PLANNING COMMISSION AGENDA
Monday – January 8, 2007
7:00 PM - Regular Meeting

DR 06-10 – 1410 S Township Road - Site and Design Review approval for a two story warehouse building **Page 2**

- STAFF REPORT -

DR 06-10

UPPER FLOOR PLAN SCALE: 1/8" = 1'-0"

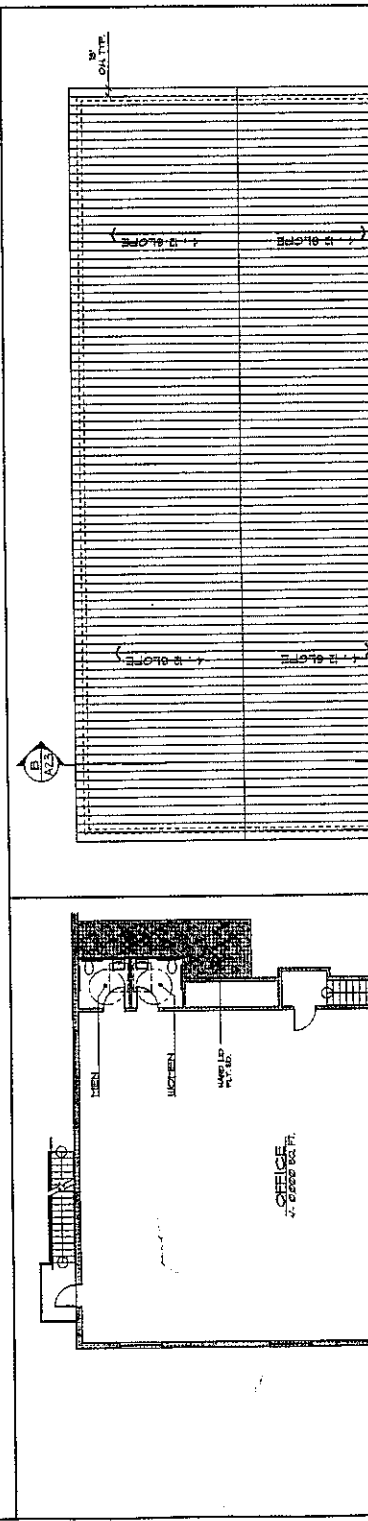
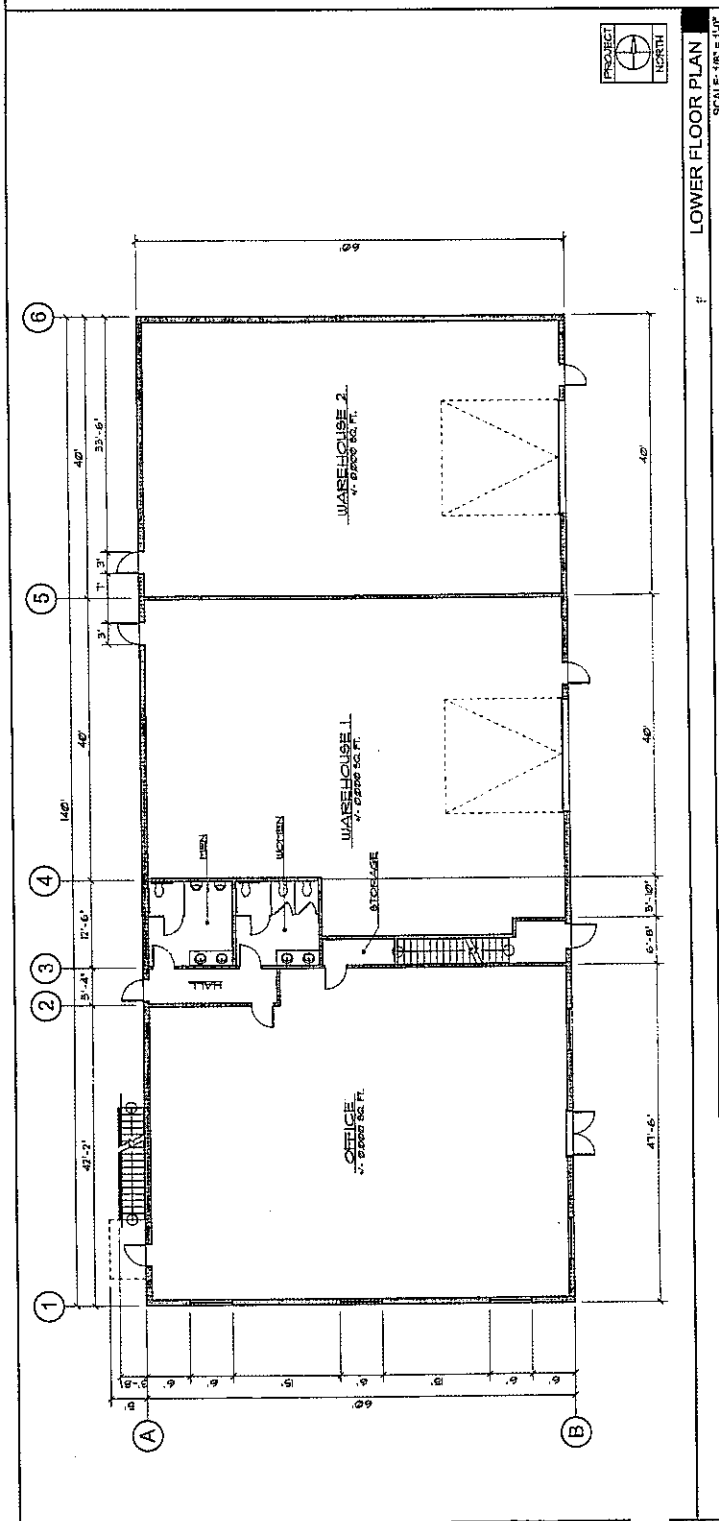
The applicant's site plan shows 13 parking spaces. However, Section 16.10.050 requires a total of 20 spaces (13 for the proposed office area and 7 for the warehouse area). Condition 5 requires the applicant to demonstrate compliance with the parking standards prior to the issuance of a building permit; the applicant may reduce the total office area, reduce the overall building footprint, produce an acceptable parking agreement with on an adjacent lot, or utilize any combination of the three options. Section 16.10.060 indicates one loading berth per an industrial use over 5000 square feet. Do area constraints, the applicant has not proposed a loading berth. The Planning Commission has in the past, allowed a waiver to this standard. Staff has recommended condition 21 in place of this requirement.

Bicycle parking rack not in evidence on plan.

No civil drawings for existing or proposed conditions were submitted. Plans should be submitted for review & approval.

Onsite storm water disposal is required. Developer should provide analysis to city. UIC systems should be approved by DEQ.

- 4. Prior to the issuance of a building permit, satisfactory evidence of a shared access easement shall be provided to the Planning Department.
- 5. Prior to the issuance of a building permit, the applicant shall submit a revised parking plan to the Planning Department. The revised plan shall comply with the parking standards set forth in Section 16.10.050 of the CMC.

EAST ELEVATION SCALE: 1/8" = 1'-0" 1

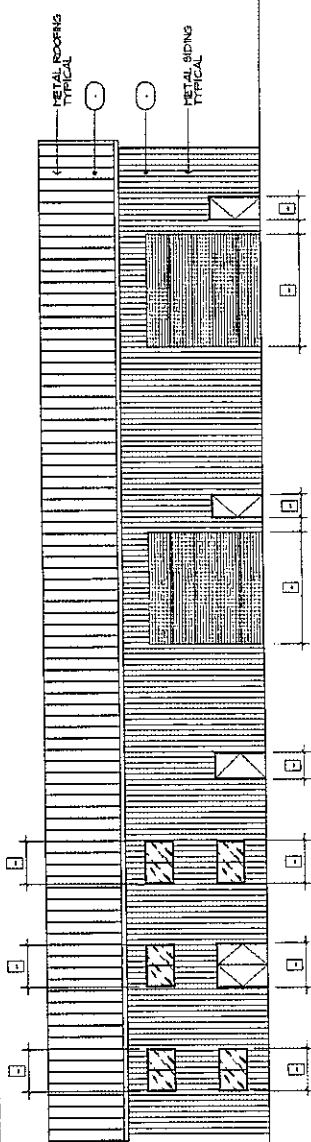
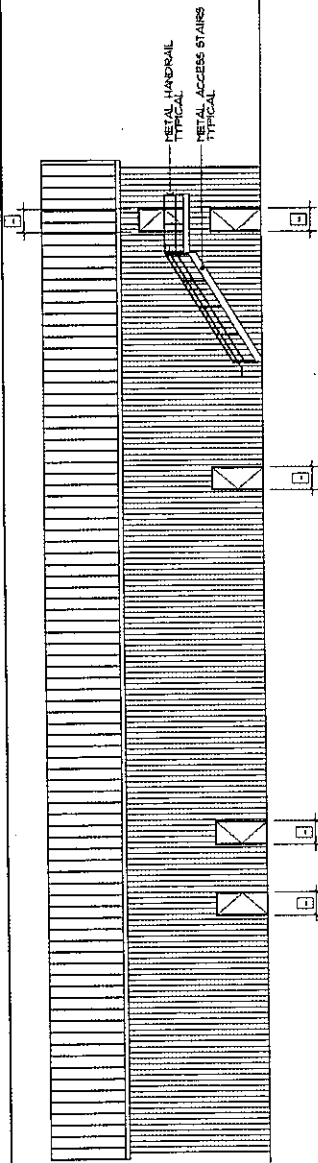
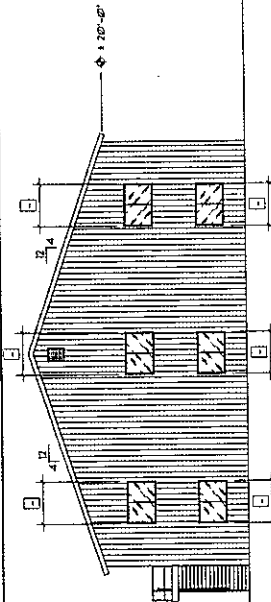
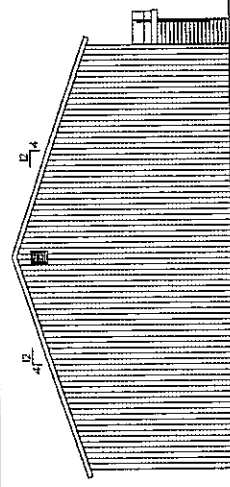
Building elevations show a basic corrugated metal building. Staff believes that although the proposed building is very basic it is, nevertheless, compatible with existing development in the area.
